SOIL/SITE EVALUATION
for ON-SITE WASTEWATER SYSTEM

IMPROVEMENT PERMIT DENIAL

Re: Application for improvement Permit for property located at 9606 Beatties Ford Rd, 01546150

Health Department file #12065B

Soil & Site Evaluation Map

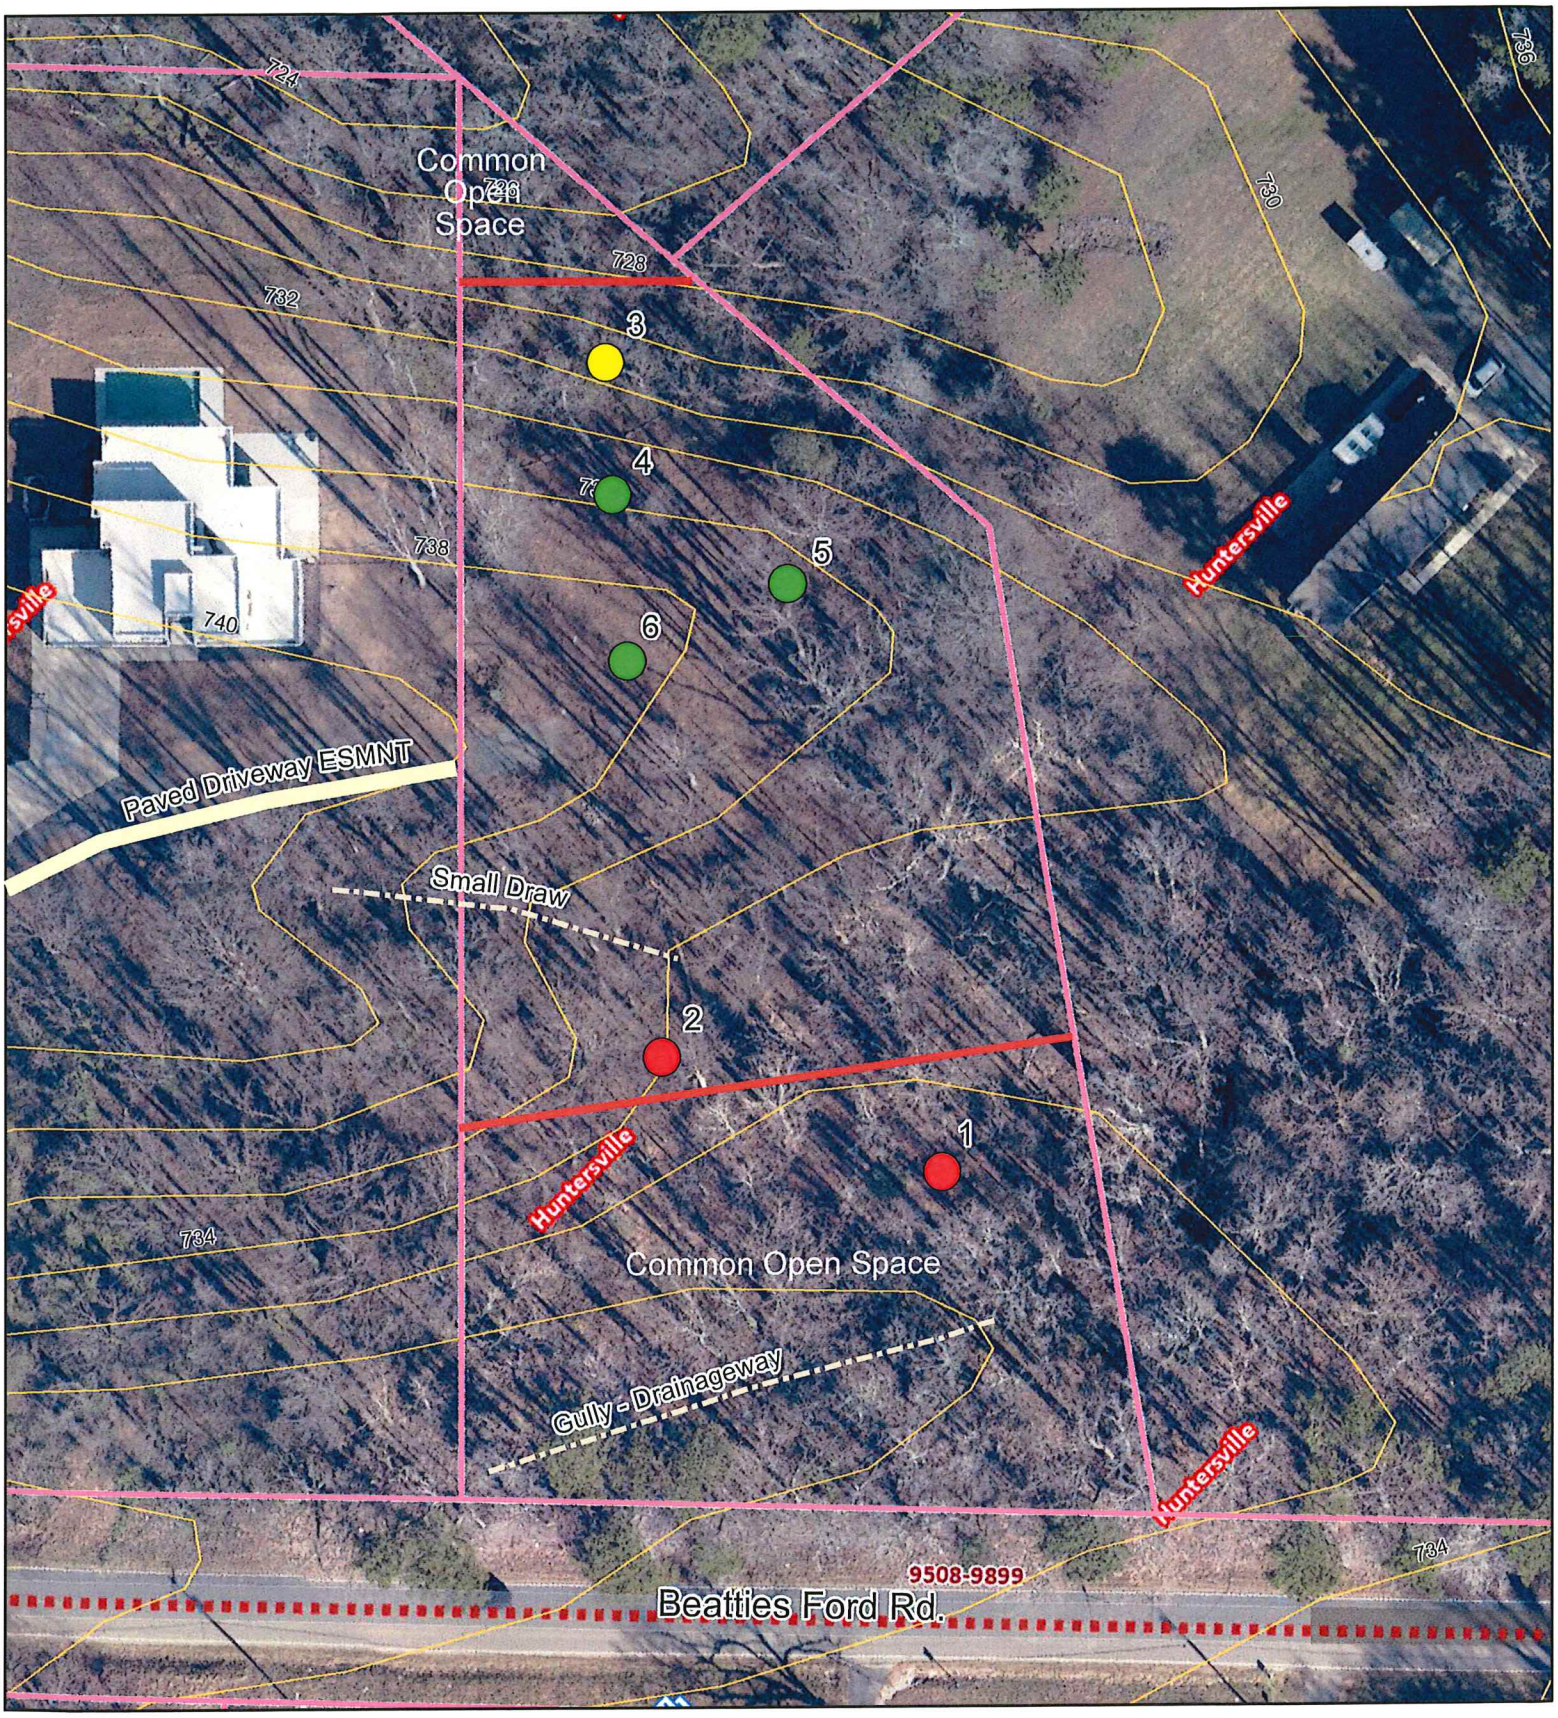
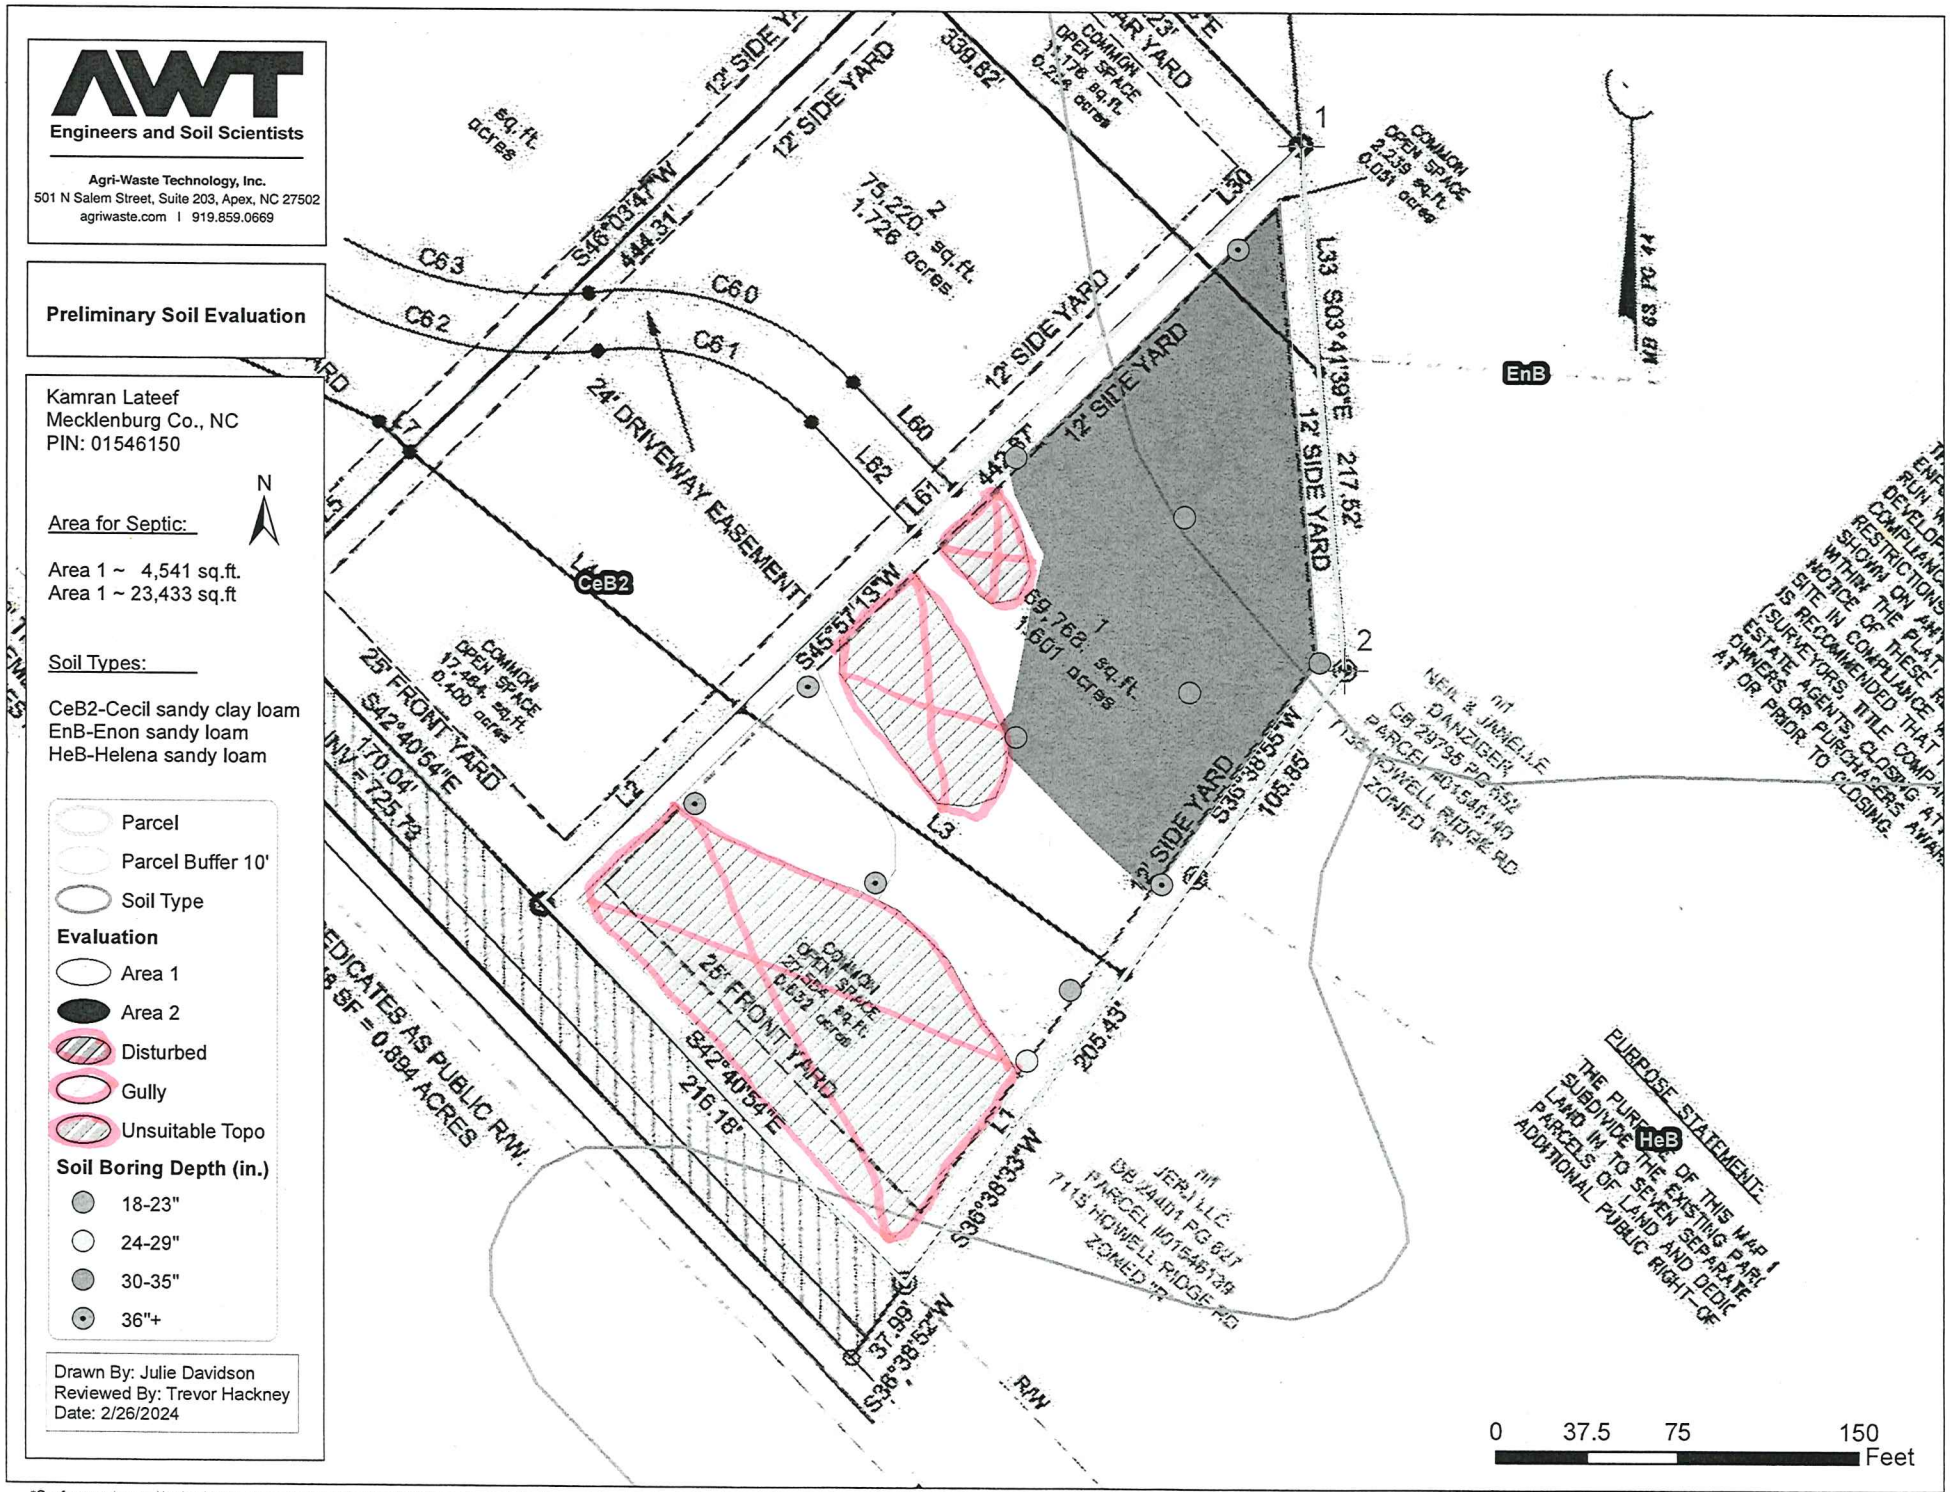
COMMENTS: The locations and dimensions of the home, the 3-4 car garage, and the pool not known nor are they marked in the field. Suitable soils and topography limited to the areas of soil borings #3 - #6. Their preferred septic area would need to be a drip, LPP, or other shallow placed engineered system.

PROPOSED PLOT PLAN

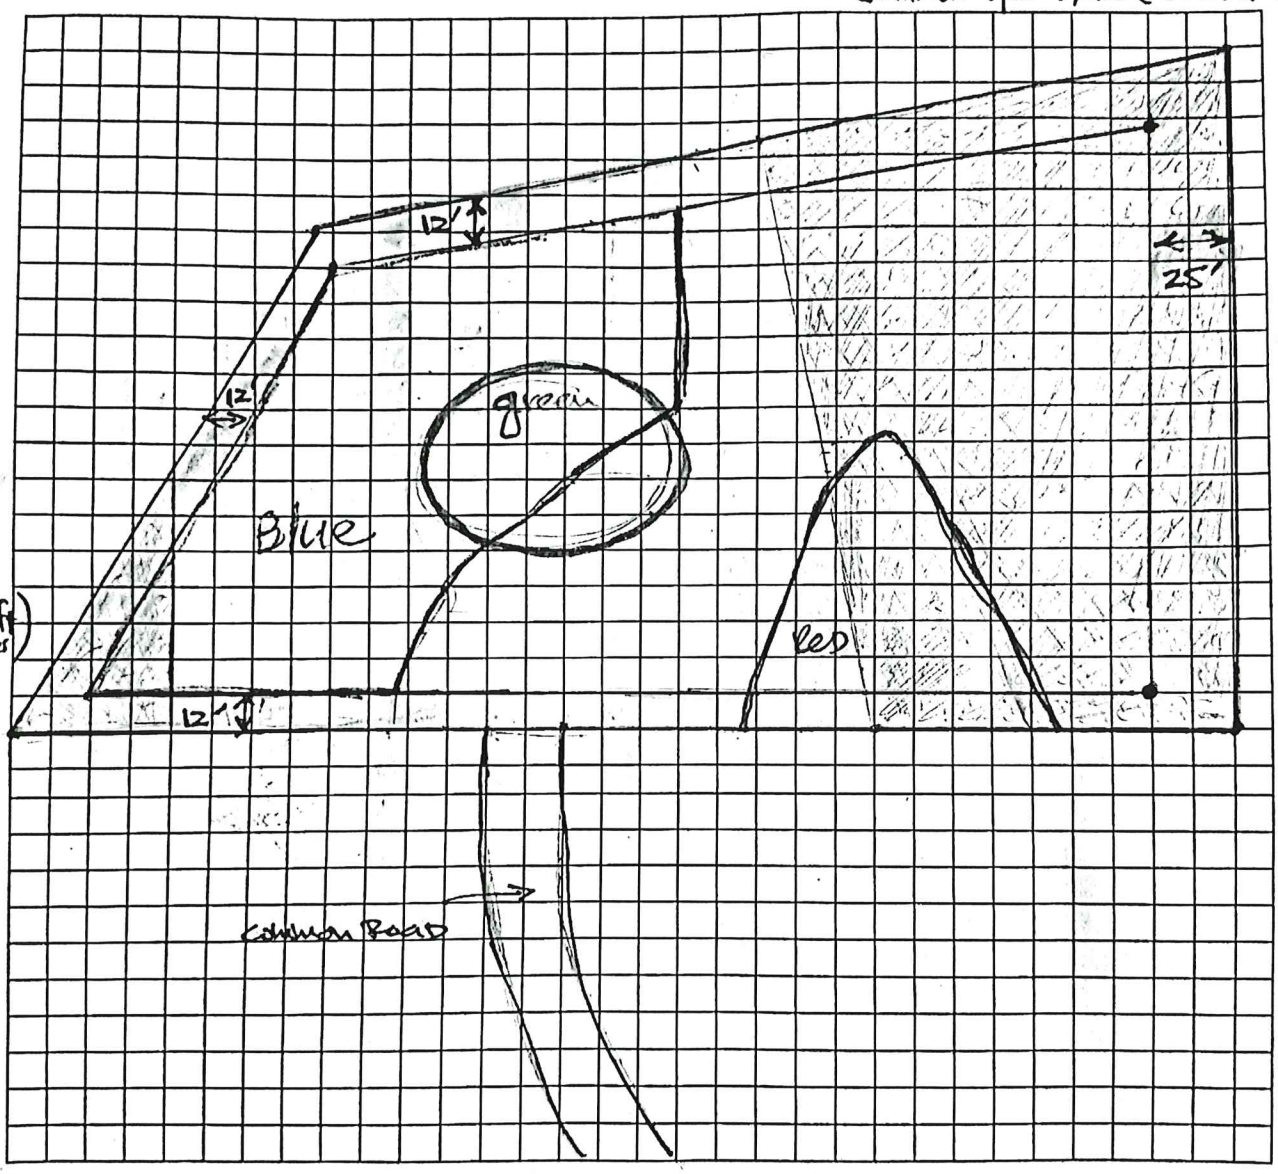
Shaded area—common space—we desire for the septic drain field to be in the large common space, if possible so we can maximize buildable space.

Area 1 (blue) and 2 (red) are proposed septic sites by the soil surveyor (see attachment for official report).
#1 choice to use Area 2 (red) for septic system with the drain field in adjacent common space.

Green circle, desired home site. 5000-6000 sqft home, 3-4 car garage, outdoor pool likely in the back of property.
